UNITED STATES PATENT AND TRADEMARK OFFICE

APPLICATION NO.	FILING DATE	FIRST NAMED INVENTOR	ATTORNEY DOCKET NO.	CONFIRMATION NO.
10/811,568	03/29/2004	Rick Mountjoy	MR03-0001	1391
45467 7590 02/09/2007 GARY F. WITTING 5834 EAST OAK STREET SCOTTSDALE, AZ 85257			EXAMINER CAJILIG, CHRISTINE T	
			ART UNIT 3637	PAPER NUMBER
SHORTENED STATUTORY PERIOD OF RESPONSE			MAIL DATE	DELIVERY MODE
3 MONTHS			02/09/2007	PAPER

Office Action Summary

DETAILED ACTION

Killen (U.S. Publication No. 2004/0128948)

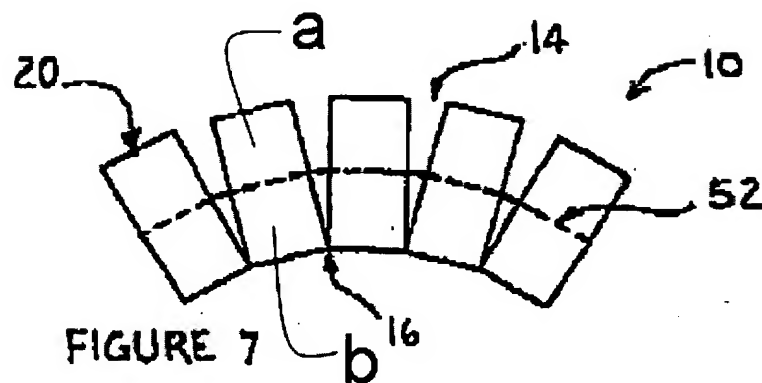
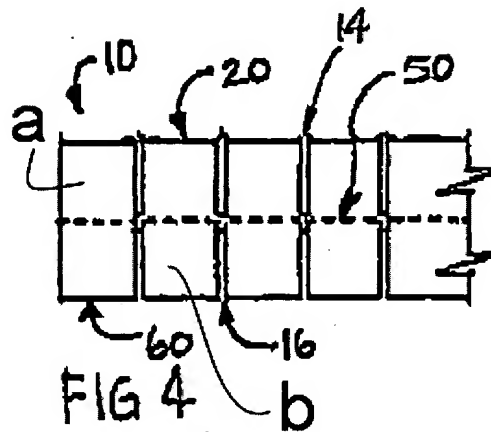
Regarding claim 1, Killen in Figure 2 discloses a construction element comprising a flexible element (52) having a first surface (upper surface of 52 in contact with block

Regarding claim 6, Killen in Figure 2 discloses a construction element comprising a flexible element (52) having a first surface (upper surface of 52 in contact with block 30) and a second surface (lower surface of 52 in contact with block 40); a first block element (30); and an adhesive layer (Pg 4, Par 91) substantially adhering the first block element to the first surface of the flexible element.

Regarding claim 8, Killen in Figure 4 discloses a construction element comprising a flexible element (50) having a first surface (surface of 50 adjacent to "a" and 20); and a first block element (a) and a second block element (20), the first and second block

Regarding claim 15, Killen in Figure 4 discloses a construction element comprising a flexible element (50) having a first surface (surface of 50 in contact with "a" and 20); and a first block element (a) and a second block element (20), the first and second block elements attached to the first surface of the flexible element with a space (14) between the first and second block elements; and a spacer (cables, rods, etc. on Pg 5, Par 101) disposed between the first and second block elements.

Regarding claim 21, Killen in Figure 7 discloses a construction element comprising a flexible element (52) having a first surface (upper surface of 52 adjacent to "a" and 20), the flexible element having a curve, a first block element (a) and a second block element (20), the first and second block elements attached to the first surface of the flexible element with a space (14) between the first and second block elements; and a spacer (cables, rods, etc. on Pg 5, Par 101) placed between the first and the second

Regarding claim 29, Killen in Figure 4 discloses a construction element comprising a flexible element (50) having a first surface (upper surface of 50 in contact with "a" and 20) and a second surface (lower surface of 50 in contact with 60 and "b"); a first block element (a) and a second block element (20), the first and second block elements (a, 20) attached to the first surface of the flexible element with a space (14) between the first and second block elements; a spacer (cables, rods, etc. on Pg 5, Par 101) disposed between the first and the second block elements; and a third block element (60), the third block element attached to the second surface of the flexible element (50). Furthermore, the method set forth in claims 23 and 25 would be inherent in constructing the structure set forth above.

Regarding claim 30, Killen in Figure 4 discloses a construction element as discussed above and further discloses a fourth block element (b), the third and fourth block element attached to the second surface of the flexible element (50) with a space (16) between the third and the fourth block element.
